WATER OF LEITH FLOOD PREVENTION SCHEME

PLANNING APPLICATION

Drawing Title
WARRISTON
PLAN
SHEET 1 OF 2

#### 4.2 Overview of Flood Defences at No. 2 Howard Street

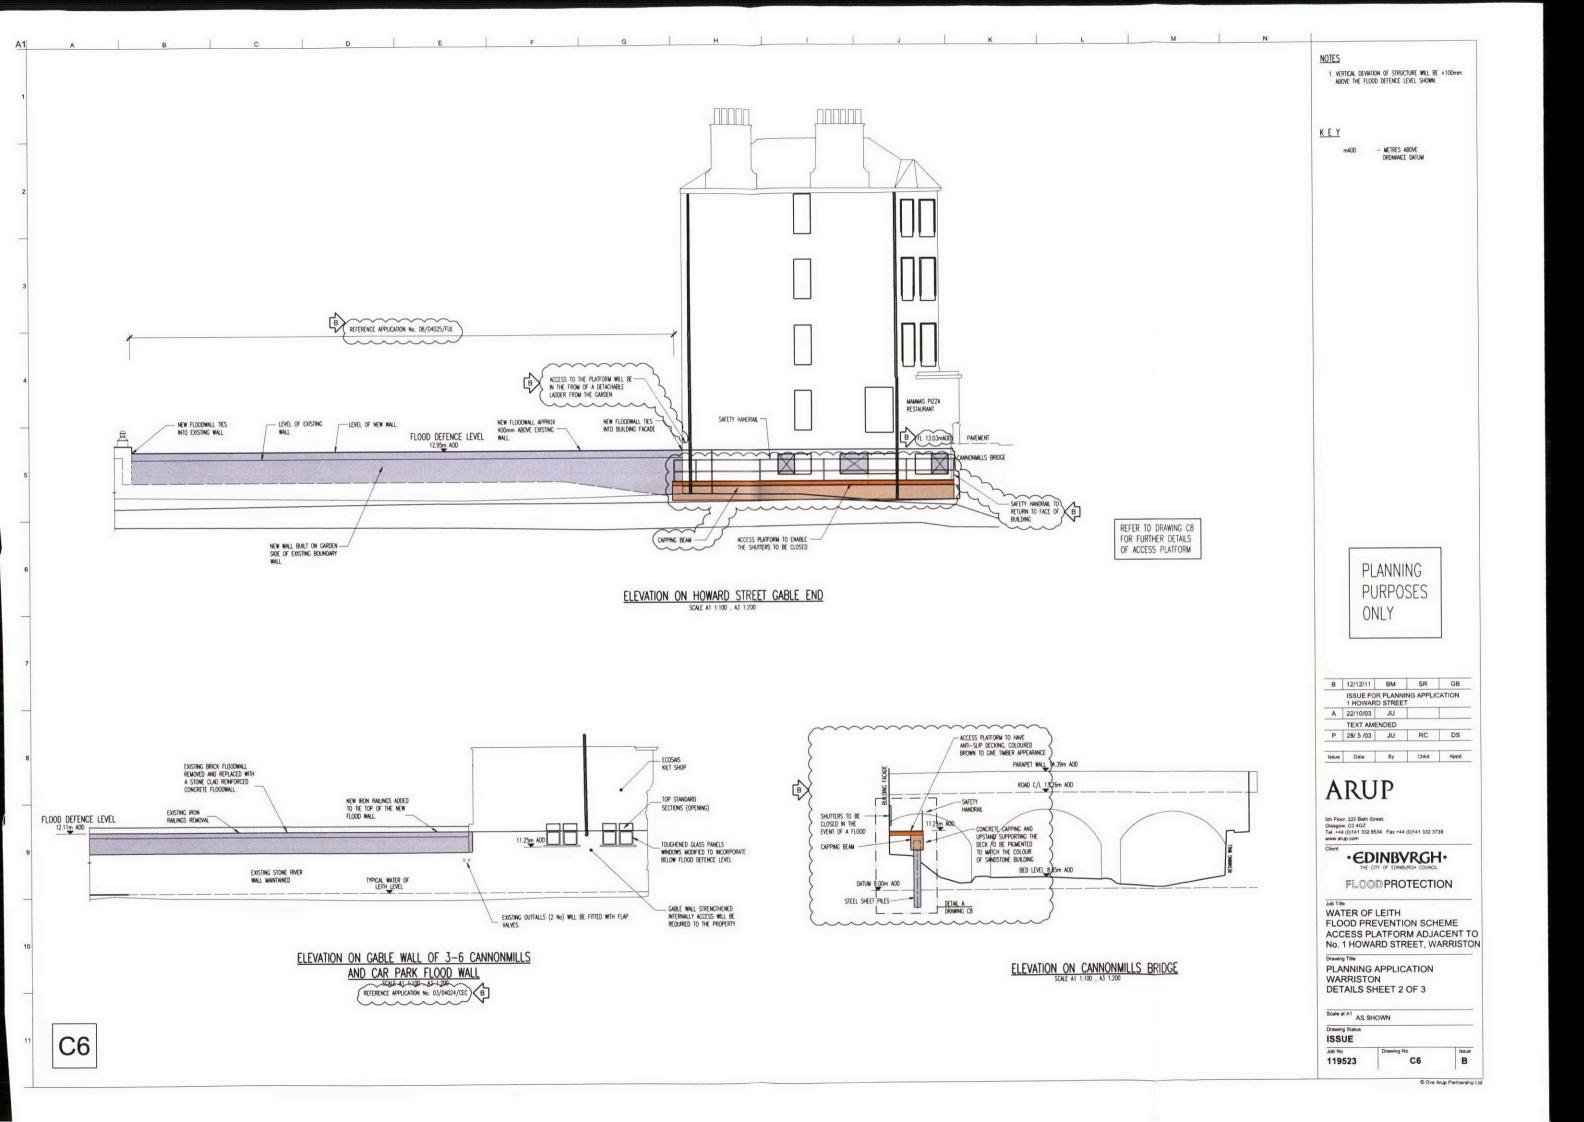
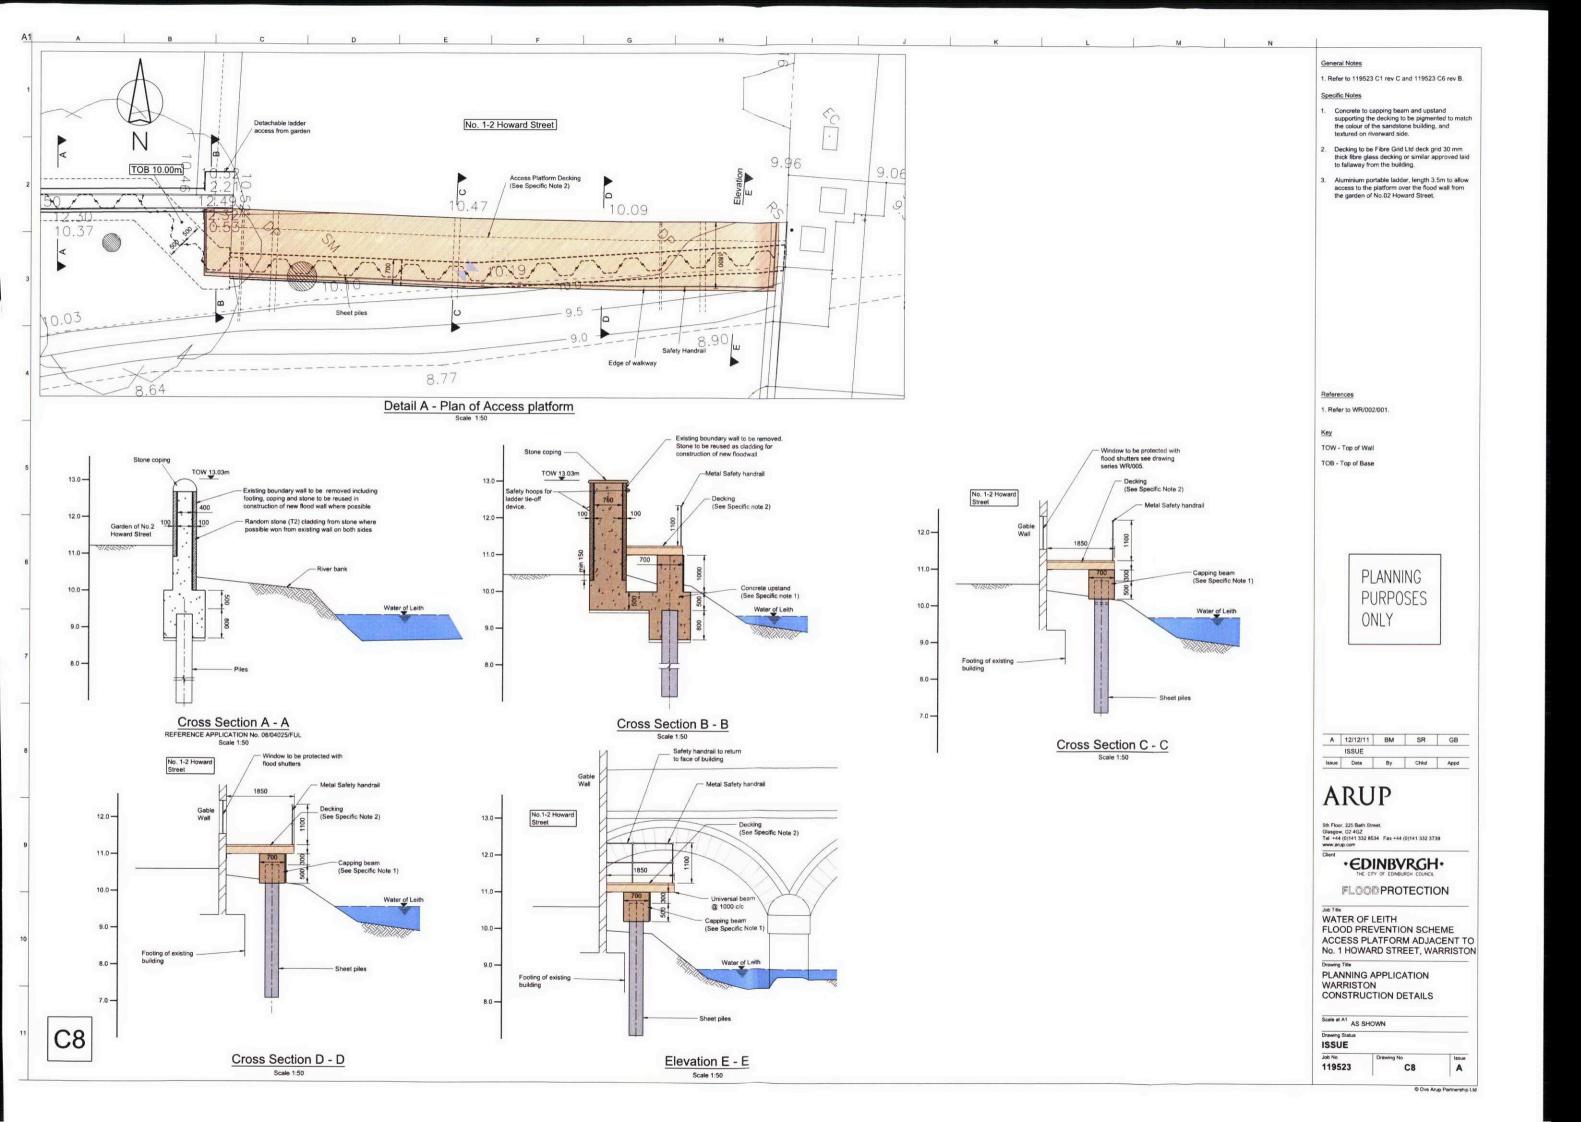
REF	DESCRIPTION
1	REMEDIAL OR STRENGTHENING WORKS MAY BE REQUIRED TO THE EXISTING WALL BETWEEN CHAINAGES 8480-8520
2	THE NEW FLOODWALL TIES INTO THE EXISTING WALL
13	BETWEEN CHAINAGES 8520-8550, THE EXISTING STONE WALL WILL BE TAKEN DOWN AND REPLACED WITH A NEW FLOOD DEFENCE WALL WHICH WILL TIE INTO THE BUILDING FACADE AT THE DOWNSTREAM END. REFER PLANNING APPLICATION No. 08/04025/FUL
4	SHUTTERS OVER THE 3 WINDOWS WILL BE PROVIDED TO BE CLOSED BY THE COUNCIL IN THE EVENT OF A FLOOD. ACCESS BY THE COUNCIL WILL BE IN THE FORM OF A DETACHABLE LADDER FROM THE GARDEN OF 1-2 HOWARD STREET AND A PLATFORM UNDER THE WINDOWS
$\sim$	MINOR REMEDIAL WORKS MAY BE REQUIRED TO THE PUBLIC CONVENIENCES

Further design has highlighted the need for changes to the previous proposals. The existing masonry wall will be taken down and replaced with a reinforced concrete wall, constructed on the same line as the existing wall, stone clad on both sides and founded on sheetpile foundations.

On the upstream side of Canonmills Bridge on the left bank, between chainages 8520 and 8550 the existing stonewall will be taken down and replaced with a new reinforced concrete flood wall with sheetpile foundations. This new wall will be constructed on the same line as the existing wall. The new wall will be finished on both sides in stone re-used from the existing wall (where possible) and will be fitted with a flush fitting, domed coping stone. The gable end of the basement property at 2 Howard Street will be strengthened internally to provide the flood defence, however it is proposed to provide flood shutters to the window openings as detailed on Planning Drawings C1 and C6. The middle window has a lower sill level than the two smaller windows at either side and it is proposed that this sill be raised to the same level as the smaller windows. A walkway to allow City of Edinburgh Council operatives to operate the flood shutters will be constructed. This walkway would be accessed from the bridge via a locked gate installed in the bridge parapet and ladder access to a platform.
